Re: 339 West Gorham Street: Oliv Madison

Attached is a minor amendment packet for the Oliv Madison Project. These changes address some program elements (expanded amenity), design refinements, and adding solar to the project. The packet illustrates the changes between the Original SIP document and the proposed amendments. The site plan review/building permit set elevations are also included for reference to show what was approved with the building permit.

UDC MINOR REVISIONS

OLIV MADISON 339 W GORHAM STREET

A13

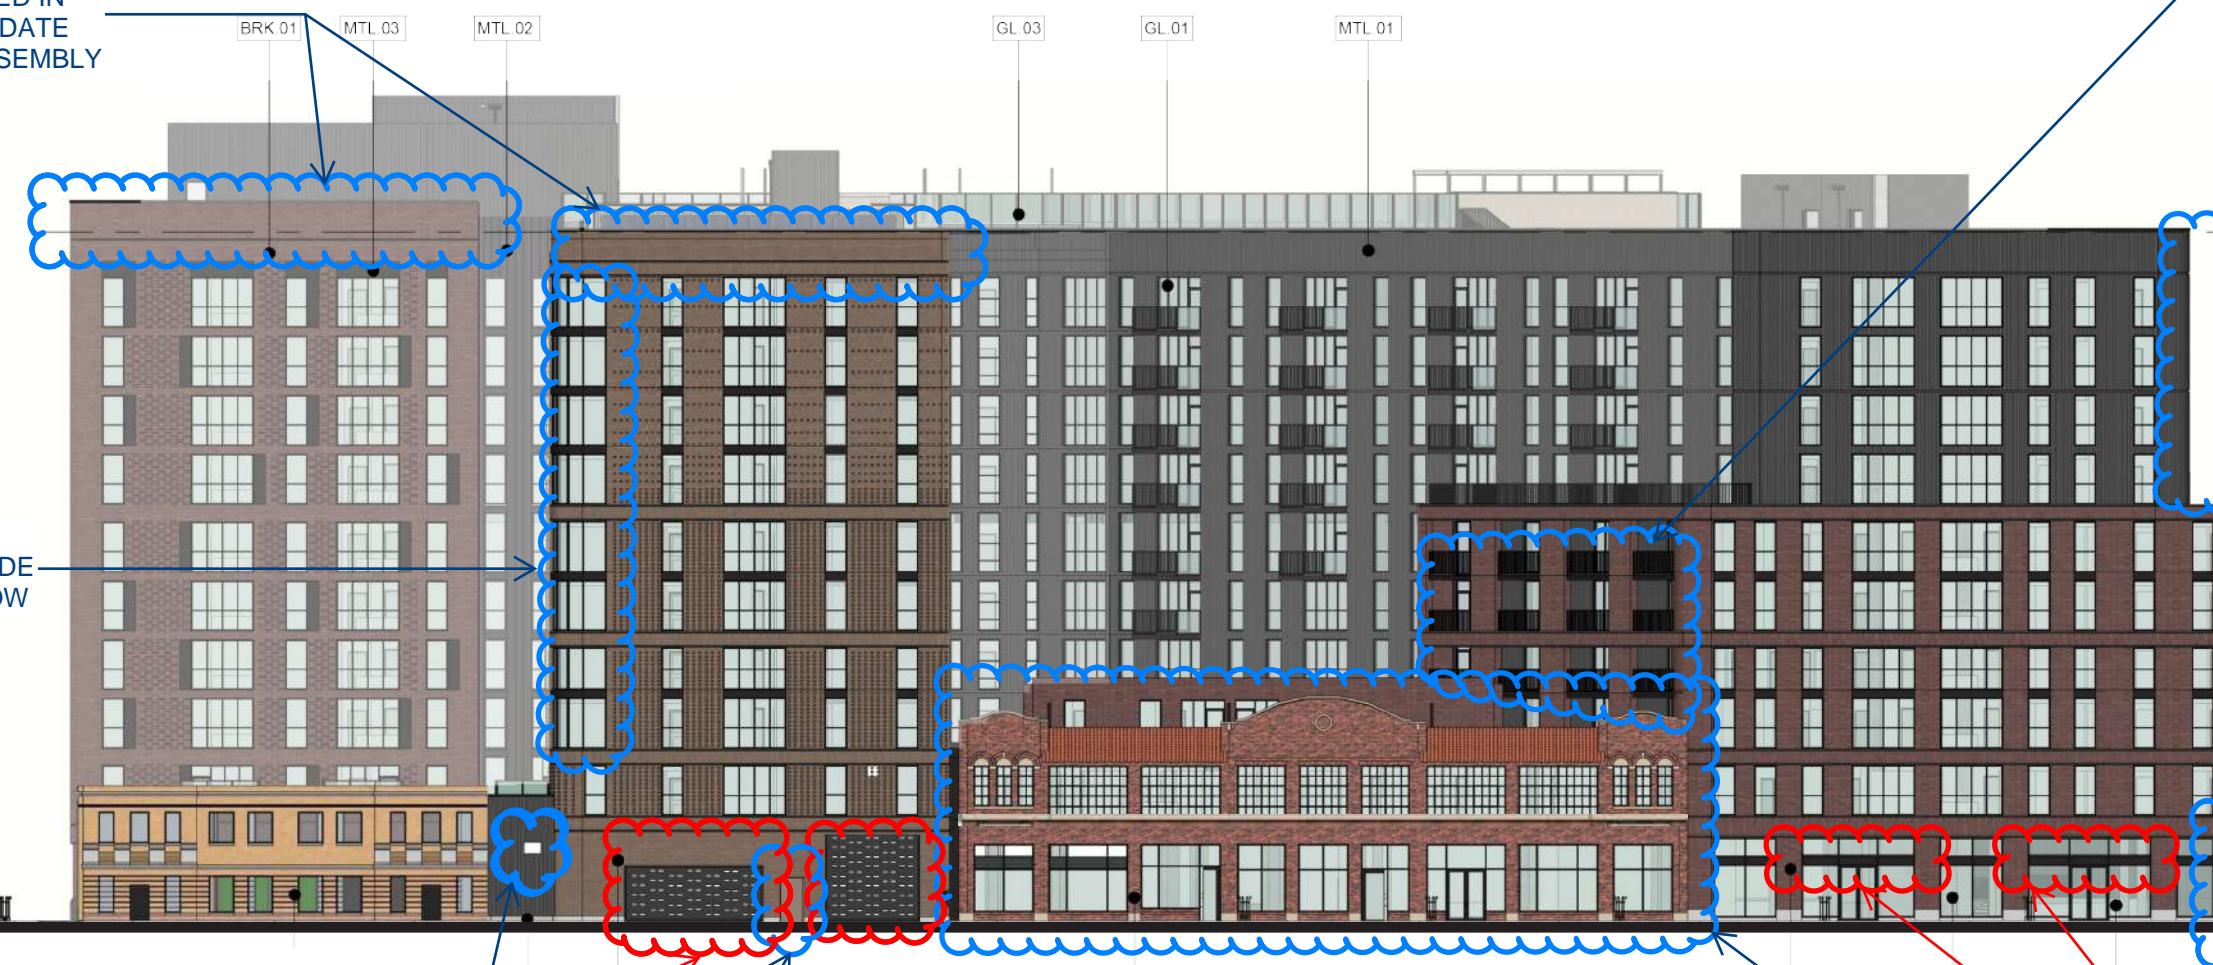
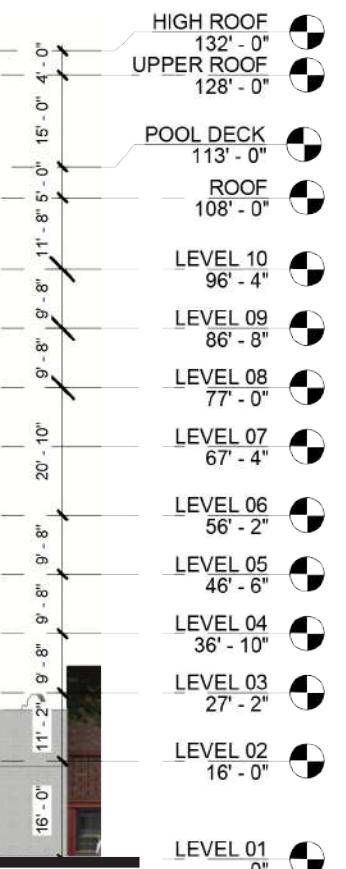
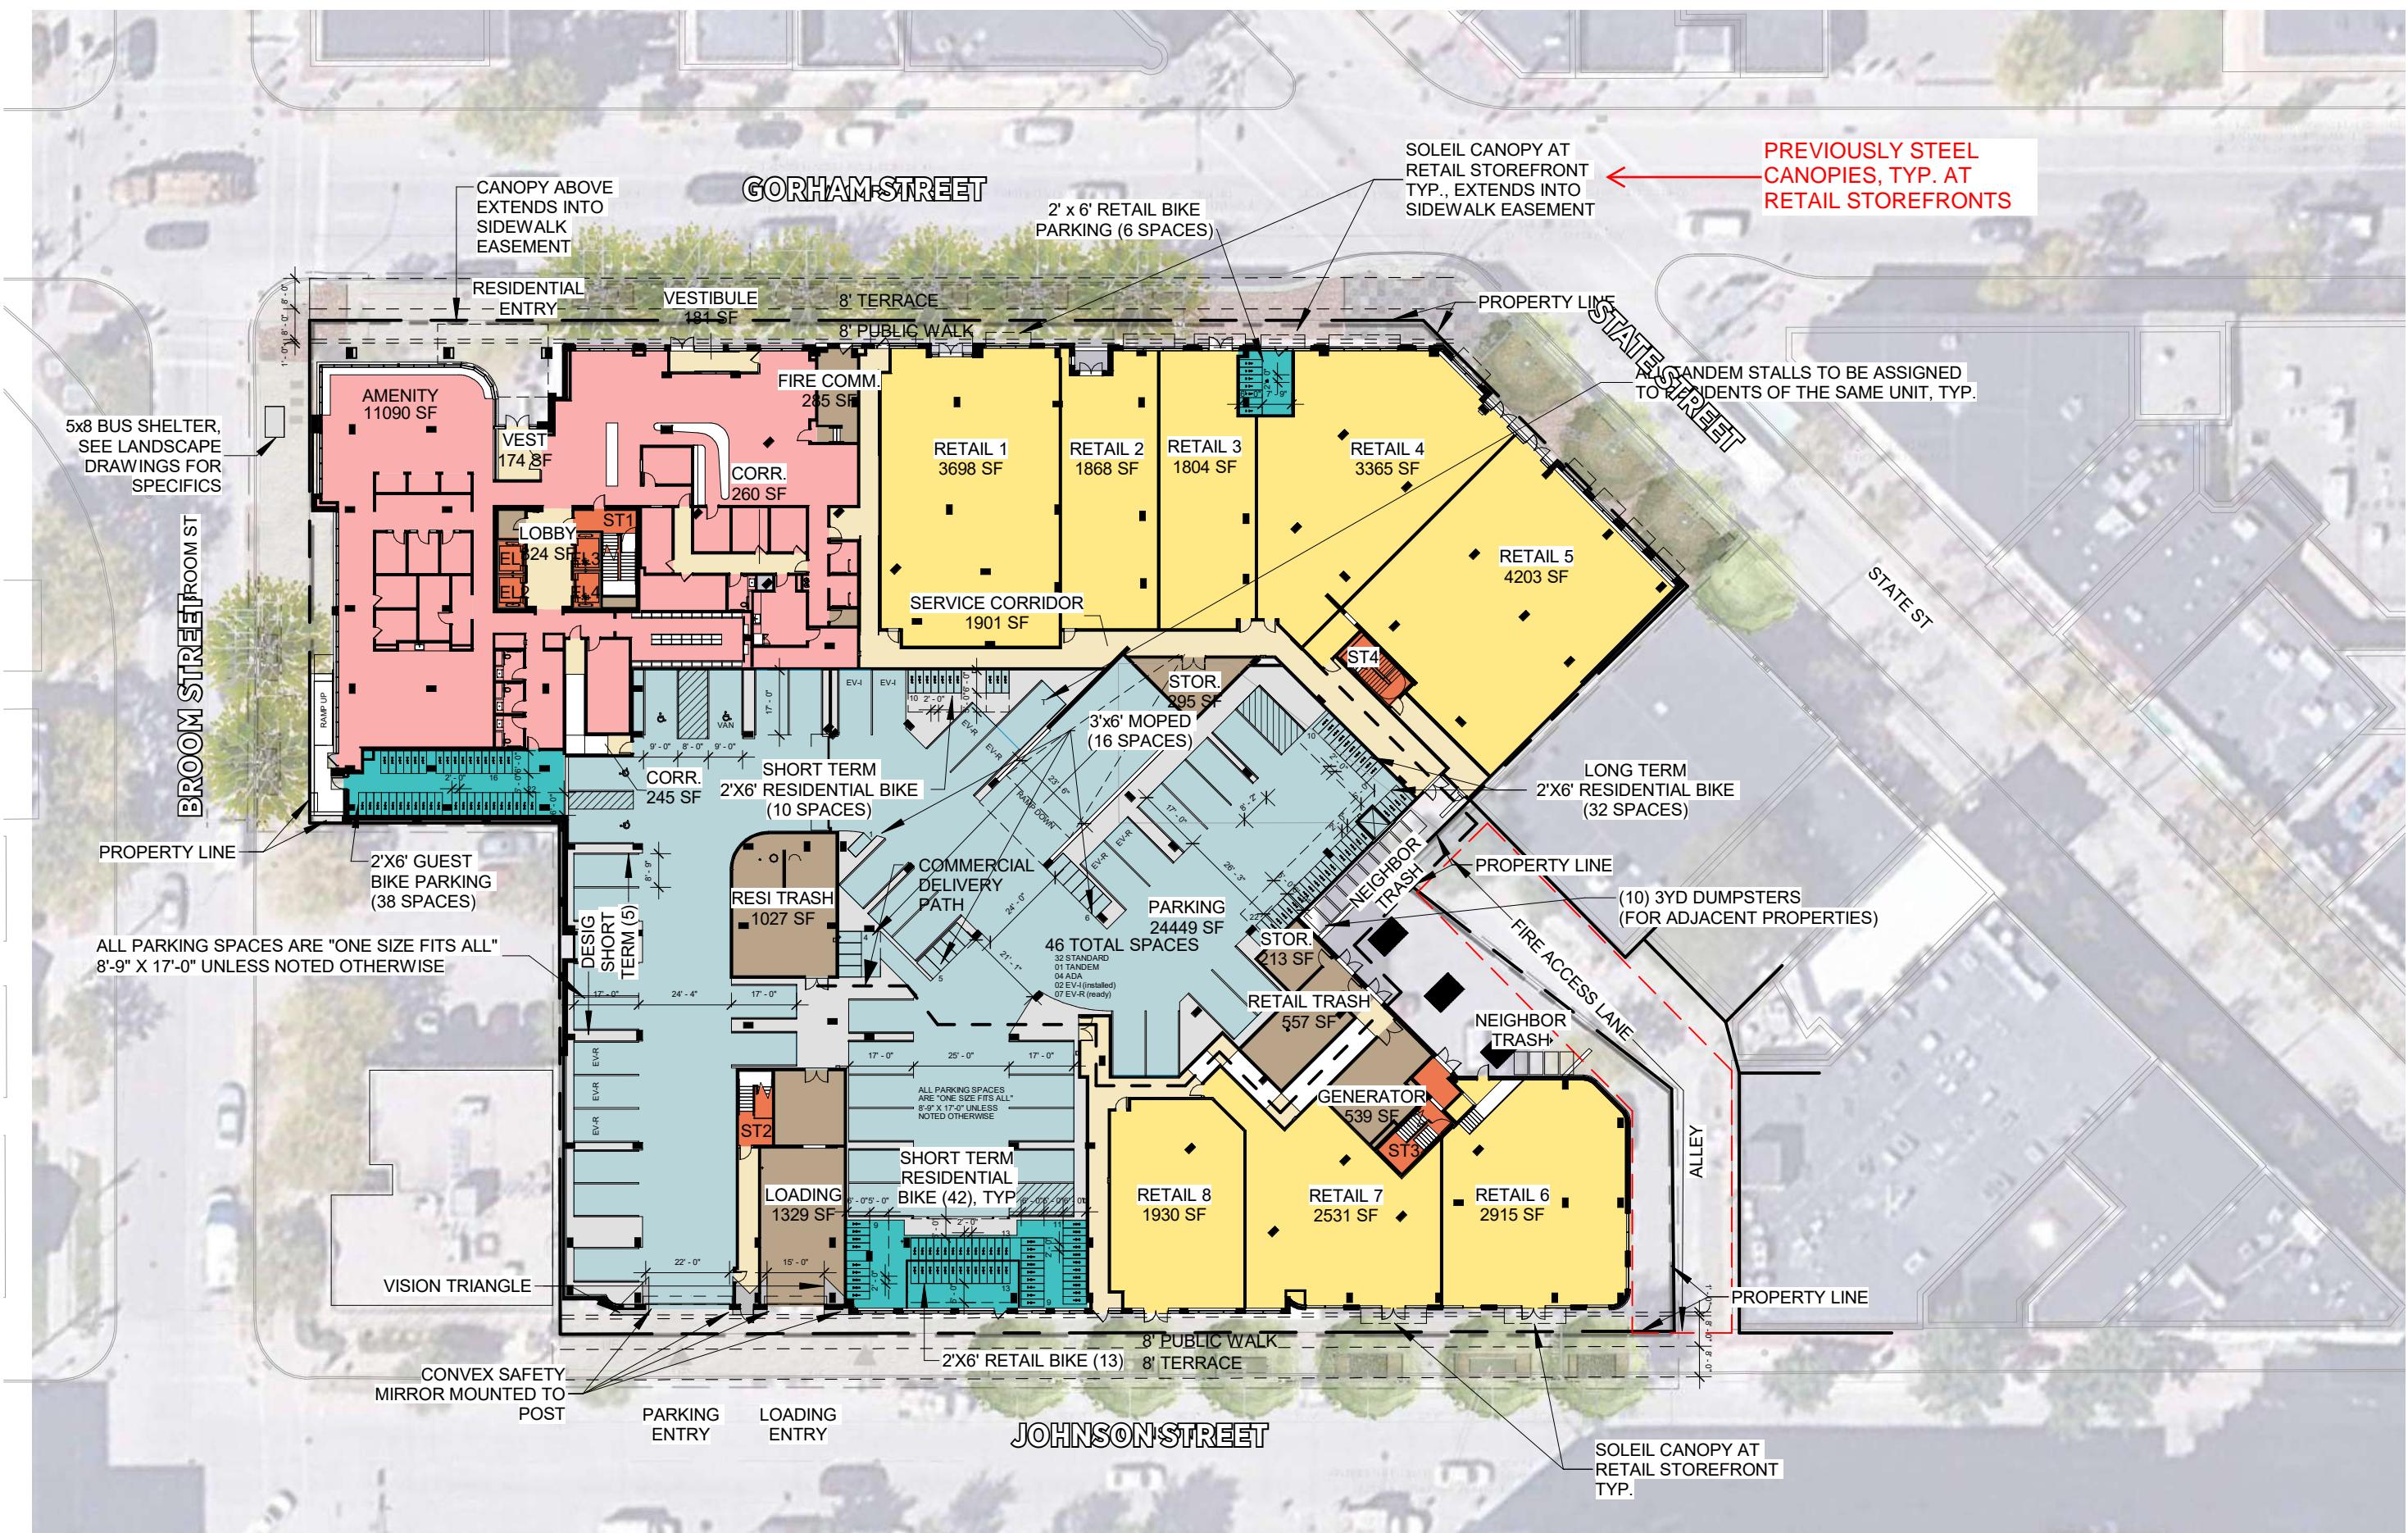
ITEM #13
PARAPETS INCREASED IN
HEIGHT TO ACCOMODATE
REQUIRED ROOF ASSEMBLY

ITEM #16
JOHNSON FAÇADE
CORNER WINDOW

ITEM #23
LOUVER REQUIRED PER MECHANICAL DRAWINGS.

ITEM #4
RESIDENTIAL GARAGE DOOR
HEIGHT REDUCED - BRICK
DETAILED ADDED. GARAGE
DOOR LITES REVISED PER DOOR
MANUFACTURER STANDARDS

ITEM #15
SELECT TENANT BALCONY RAILINGS
CHANGED FROM GLASS TO PICKET
FOR DESIGN PURPOSES

ITEM #29
JOHNSON STREET ALLEY
SETBACK

ITEM #25
CURVED GLASS REPLACED WITH
CURVED METAL PANEL TO
CONCEAL COLUMN.

ITEM #3
PROPOSING ALUMINUM
LOUVERED CANOPIES AT
RETAIL STOREFRONTS.

ITEM #24
HISTORIC FAÇADE
UPDATED PER DESIGN
DEVELOPMENT AND
LASER SCAN
